Amendments to the Drawings

FIG. 3

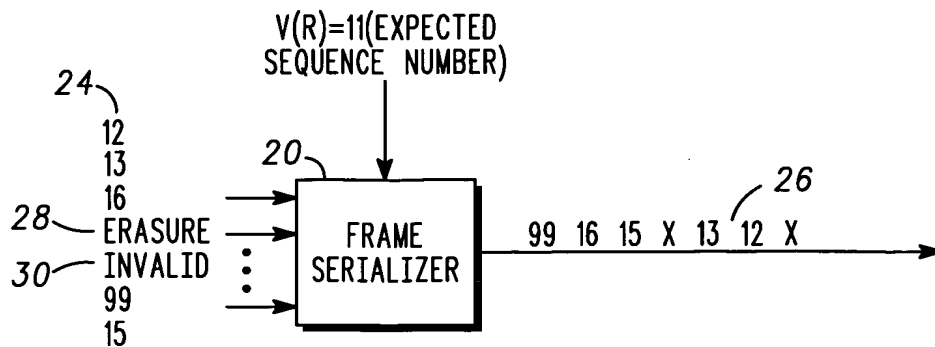
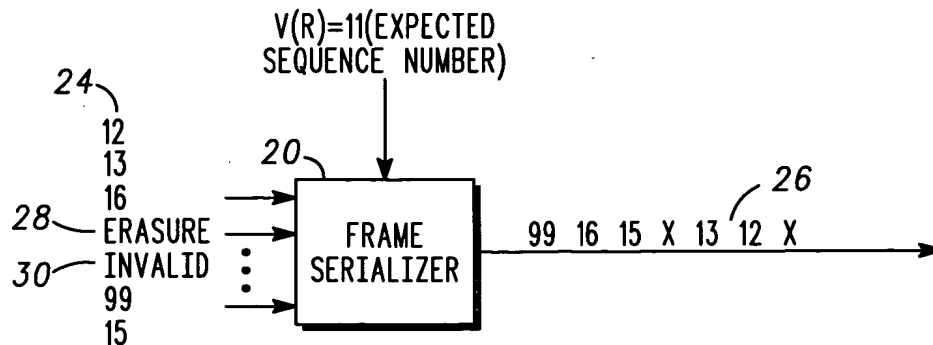
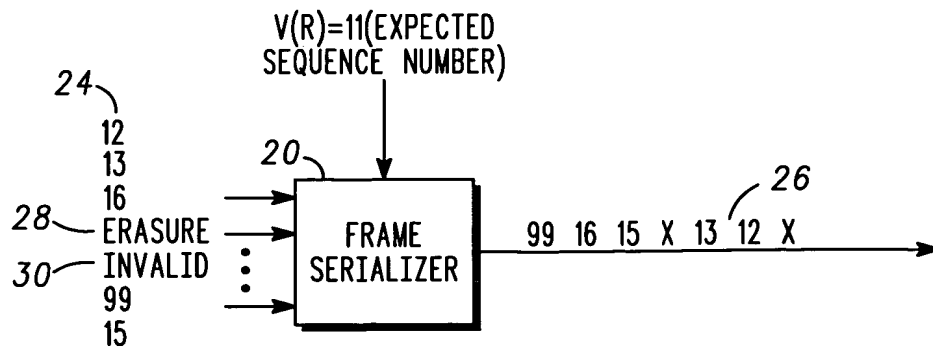
The drawings are objected to because of the missing sequence number 13 as an input to the frame serializer in figure 3. Corrected FIG. 3 is submitted herewith.
